CITY OF ALBUQUERQUE

Re: Solare Collegiate Charter School
8801 Gibson Blvd. SW 87121
Traffic Circulation Layout
Engineer's/Architect's Stamp 06-07-2019 (M09D031)

PROJECT SOLARE CHARTER SCHOOL
8801 Gibson Blvd. SW
Albuquerque, NM 87121
TITLE Traffic Control Layout

TCL

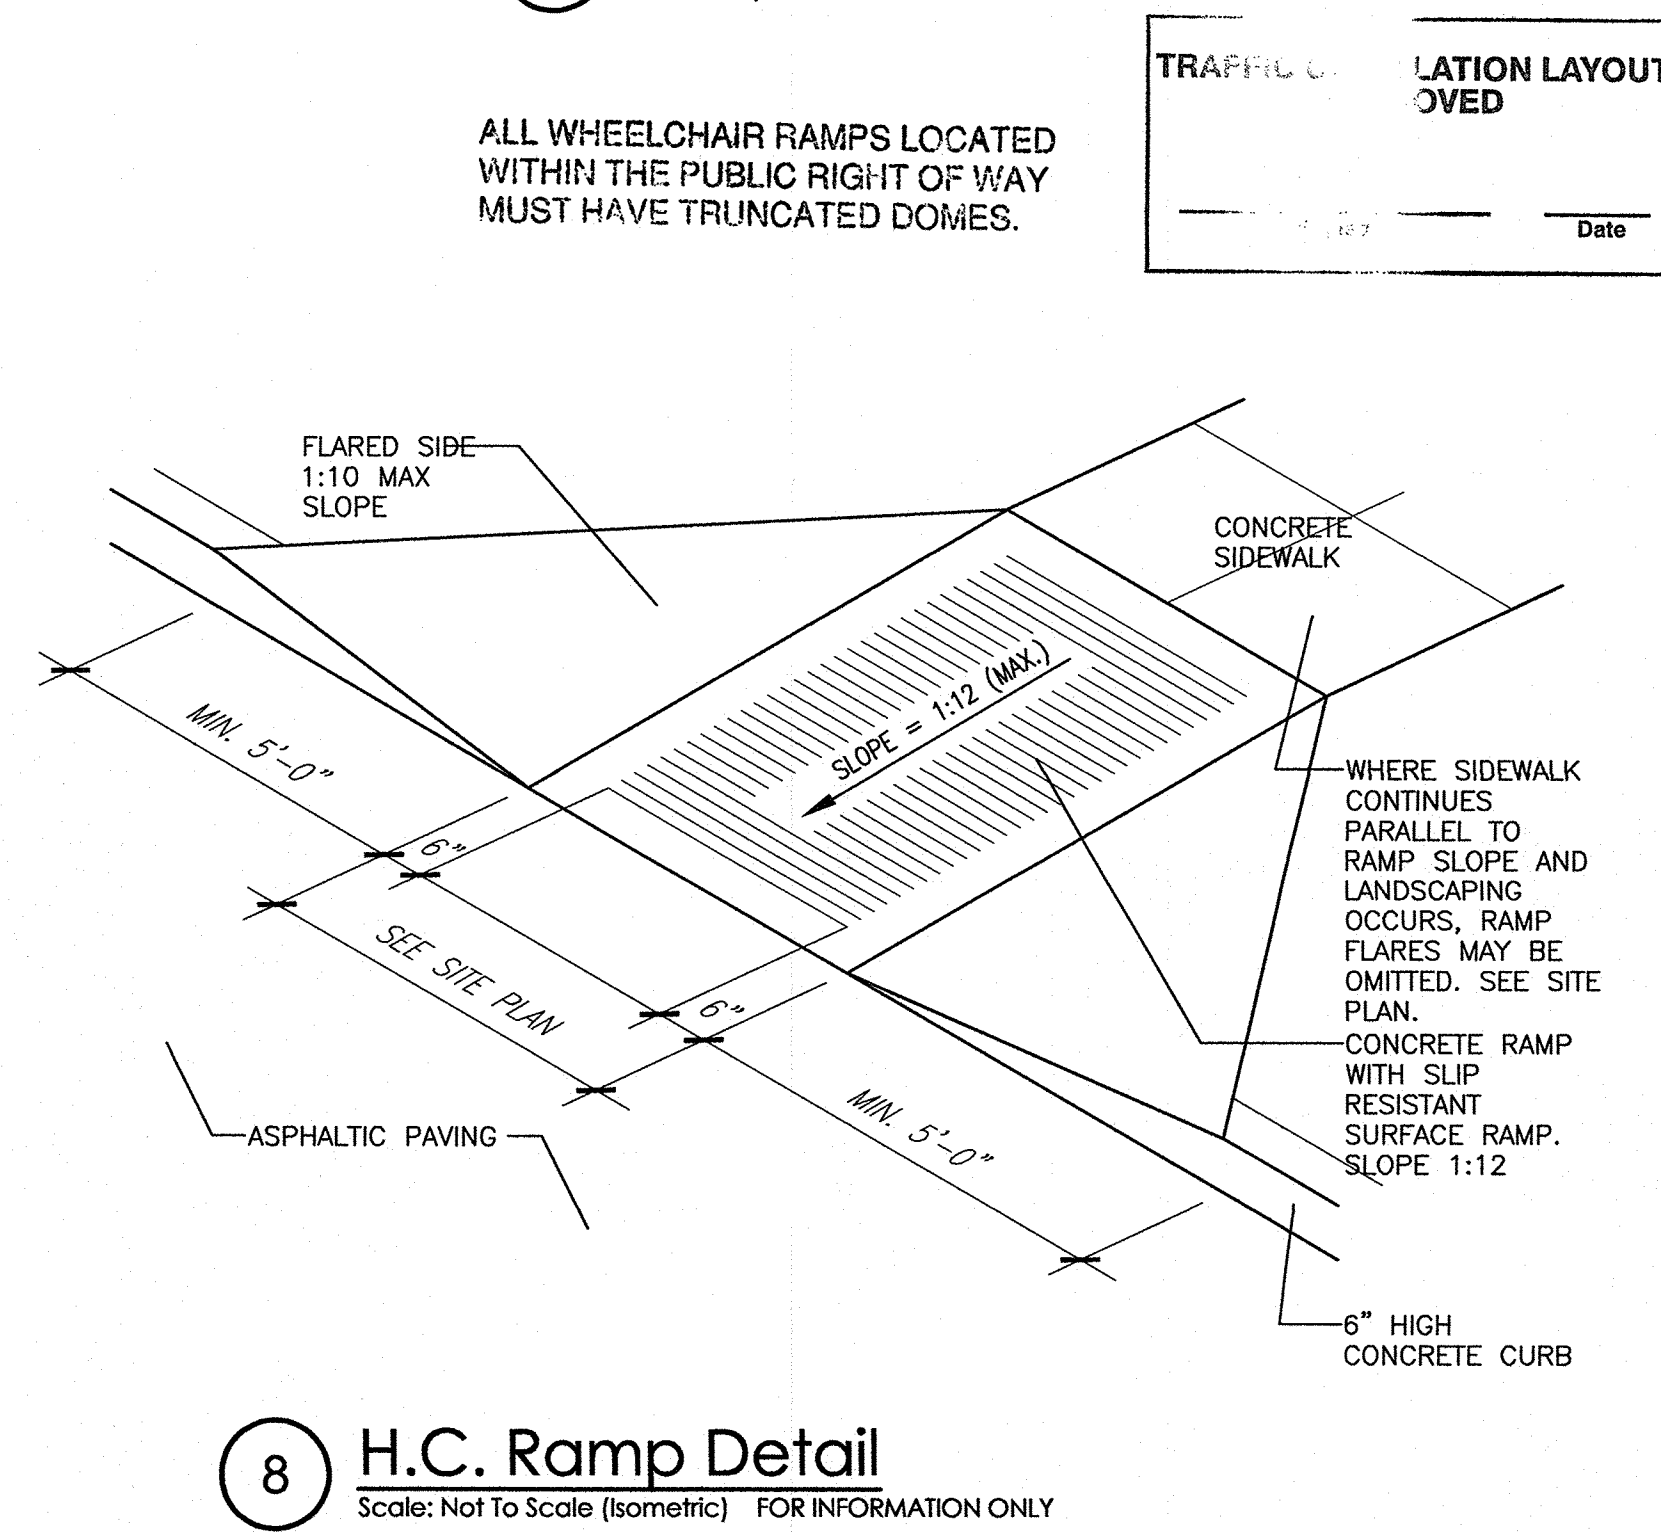
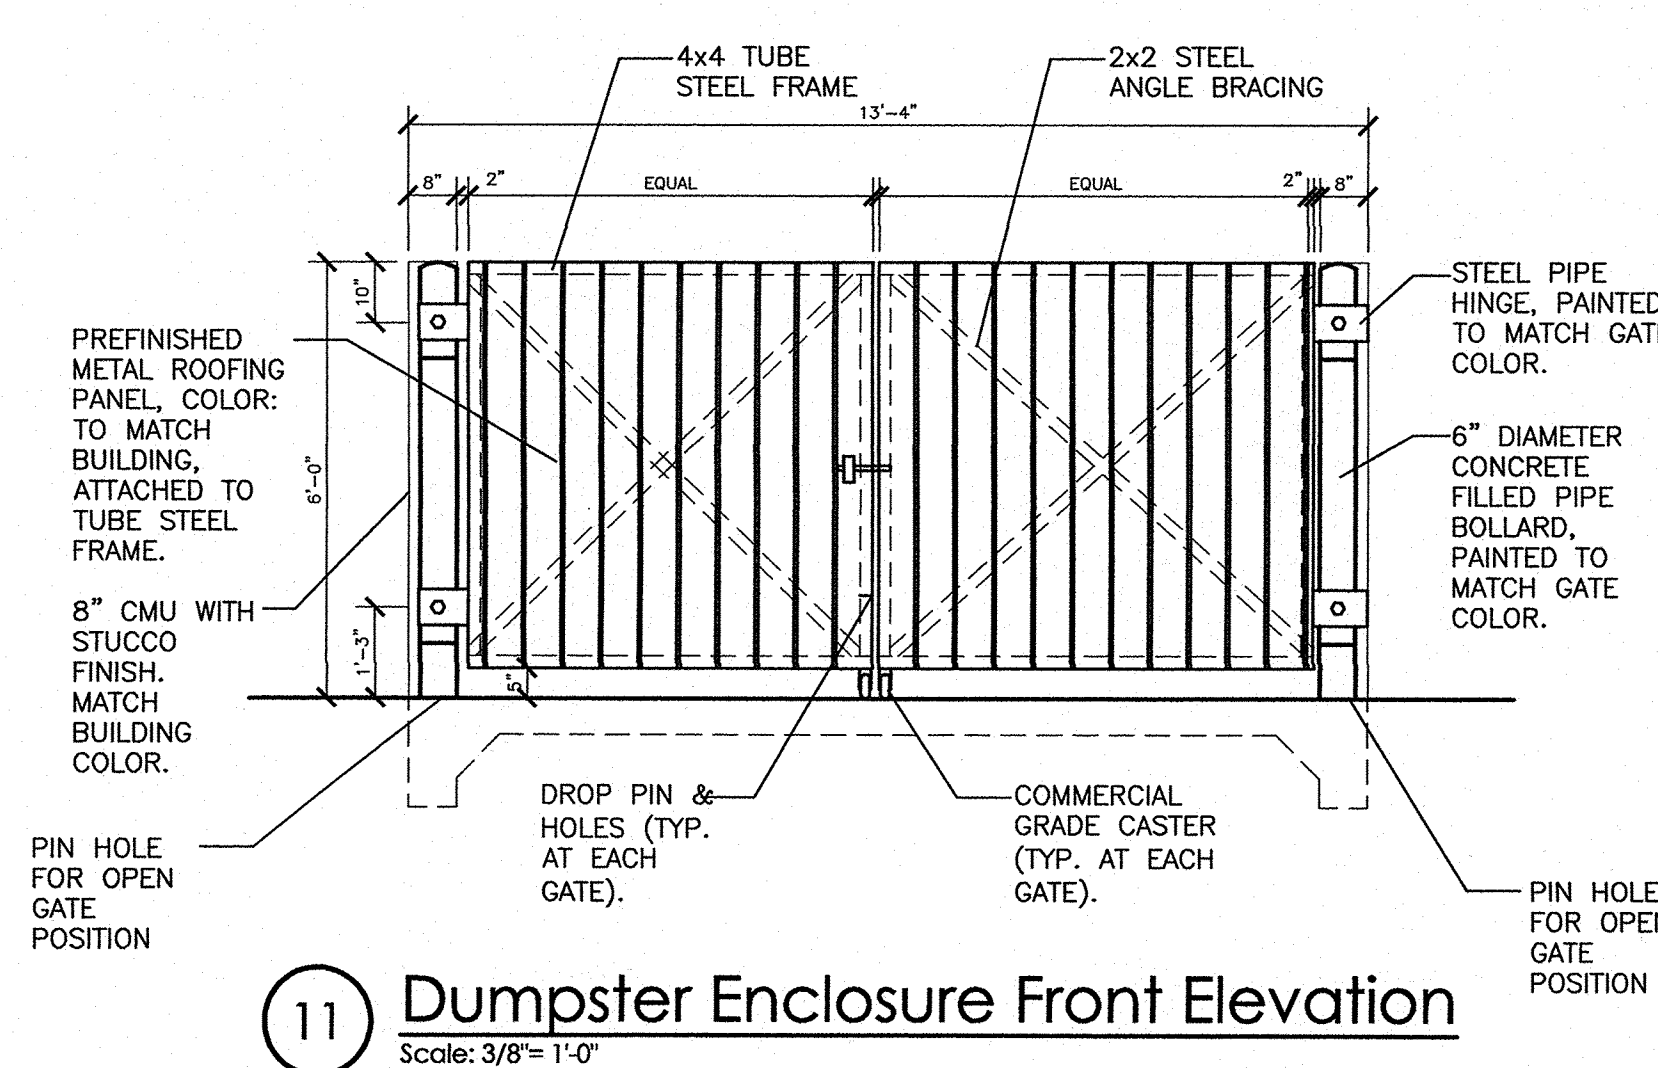
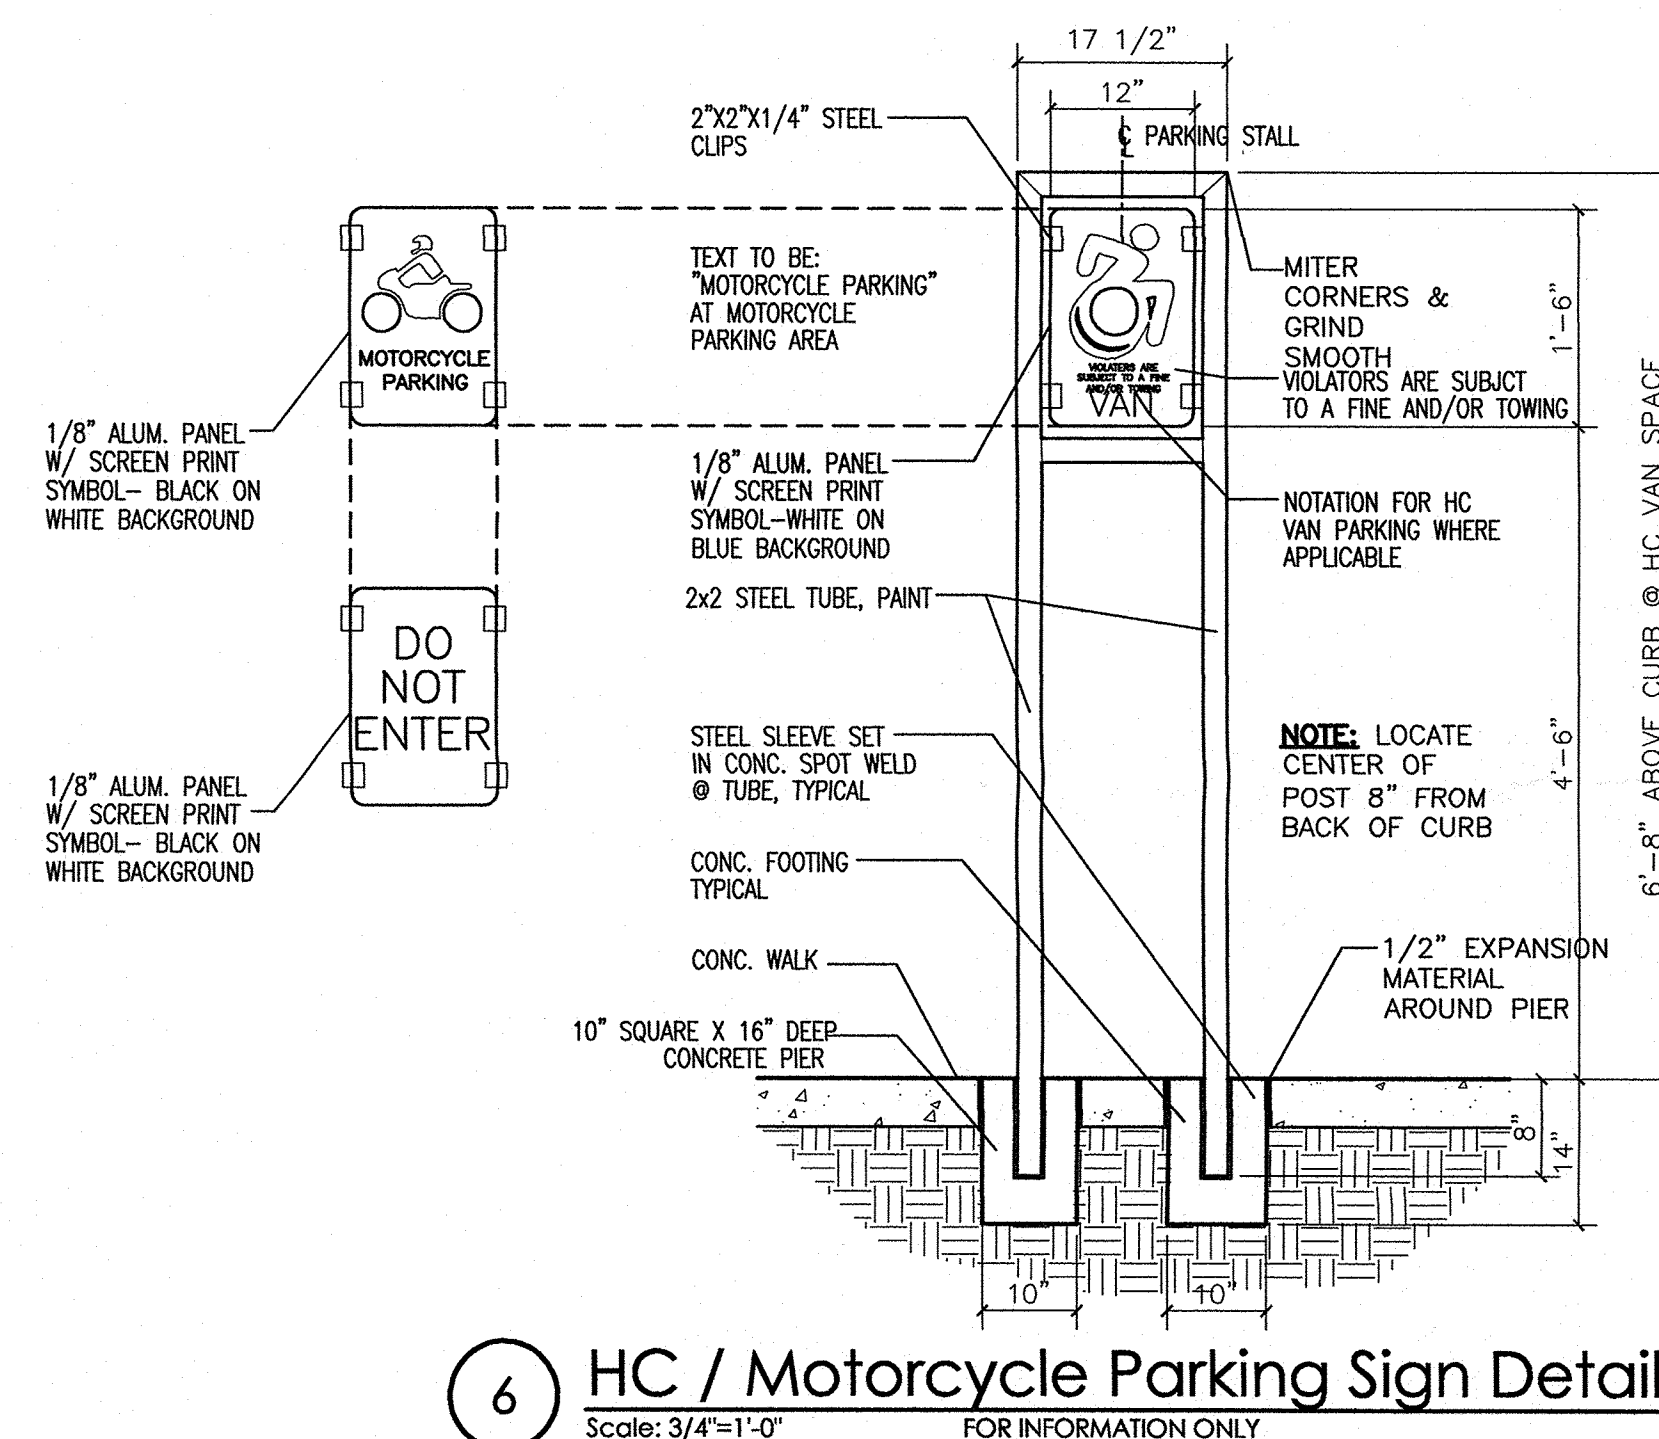
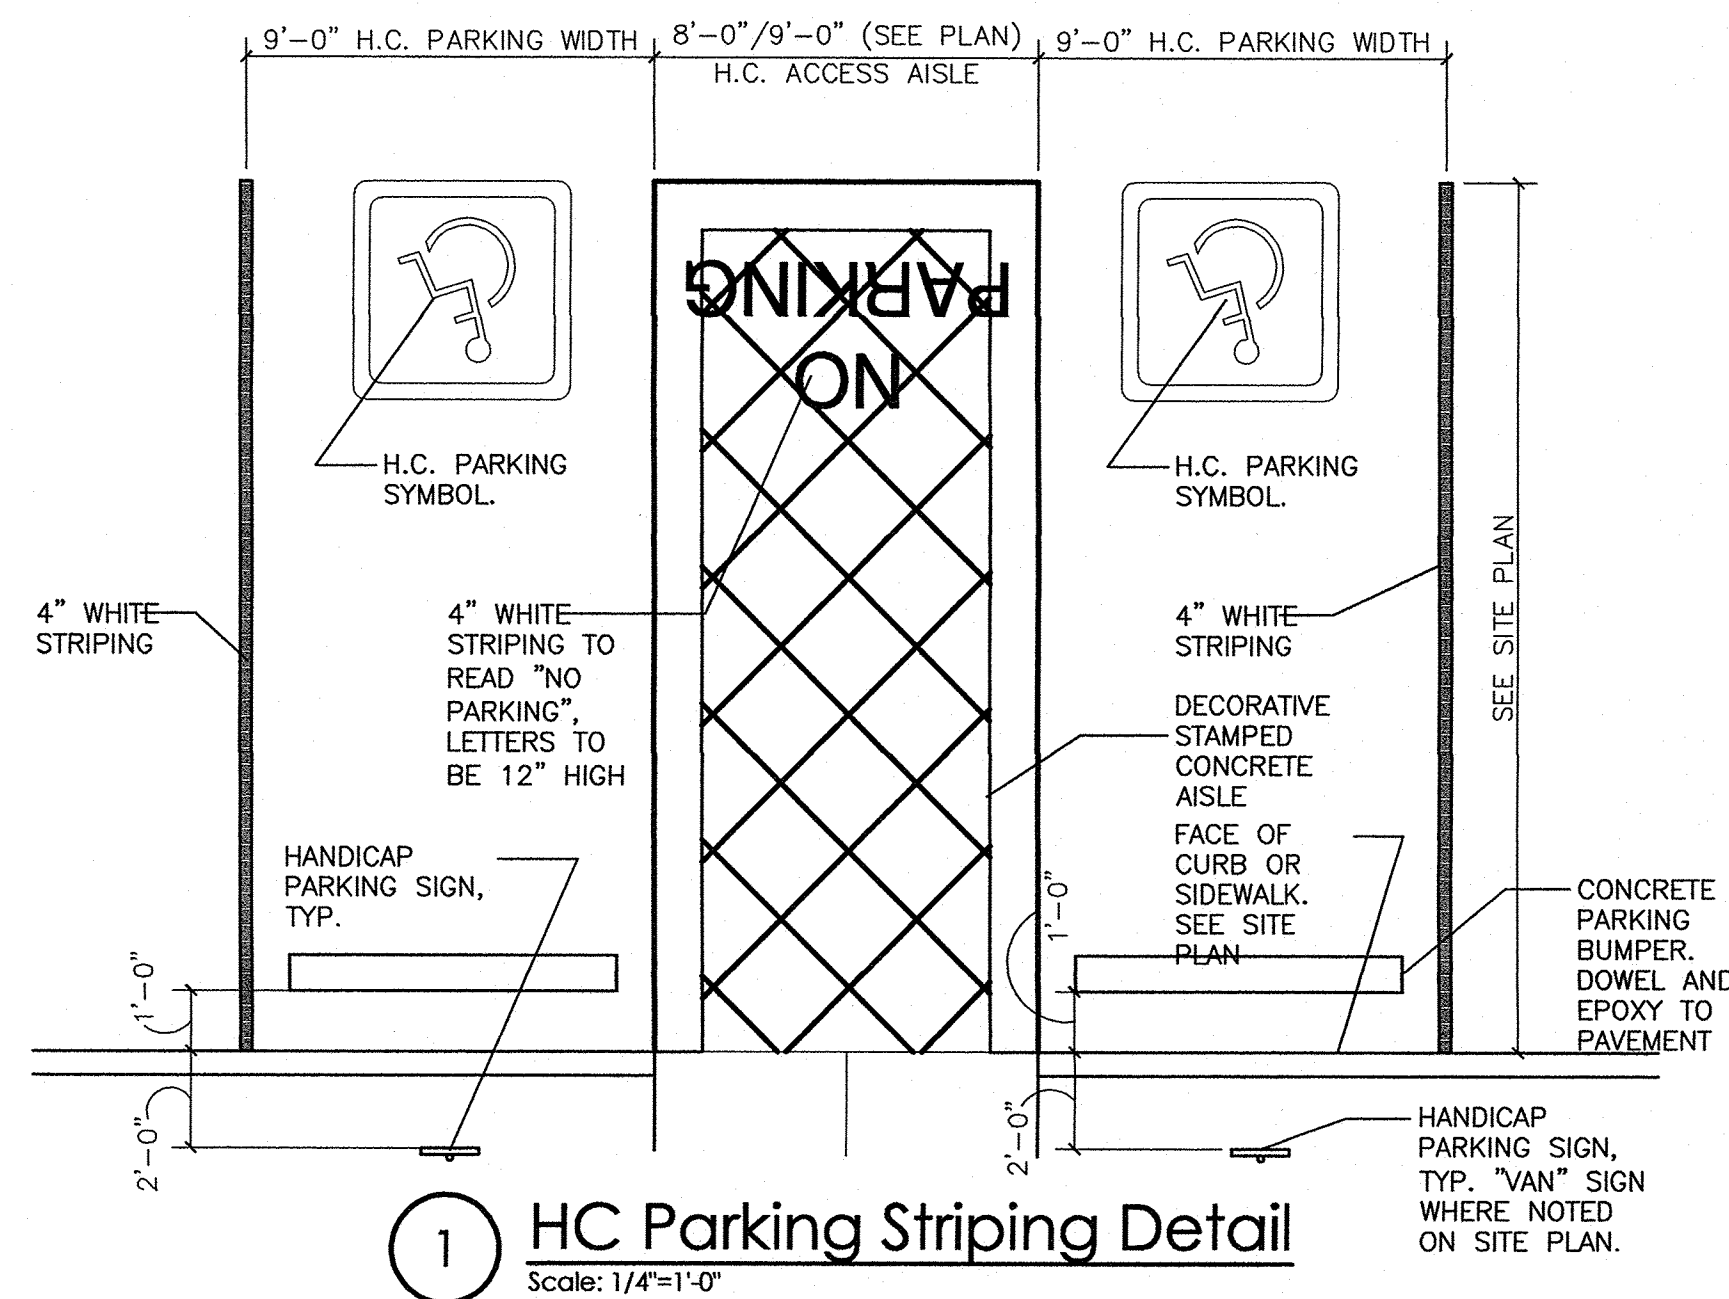
The TCL submittal received 07-23-2019 is approved for Building Permit. Per recommendation from NIA, the transportation requires work order for crosswalk striping and signs. The striping and signs will be checked at the time of the certificate of occupancy. A copy of the stamped and signed plan will be needed for each of the building permit plans. Please keep the original to be used for certification of the site for final C.O. for Transportation.

When the site construction is completed and a Certificate of Occupancy (C.O.) is requested, use the original City stamped approved TCL for certification. Redline any minor changes and adjustments that were made in the field. A NM registered architect or engineer must stamp, sign, and date the certification TCL along with indicating that the development was built in "substantial compliance" with the TCL. Submit this certification TCL with a completed Drainage and Transportation Information Sheet to front counter personnel for log in and evaluation by Transportation.
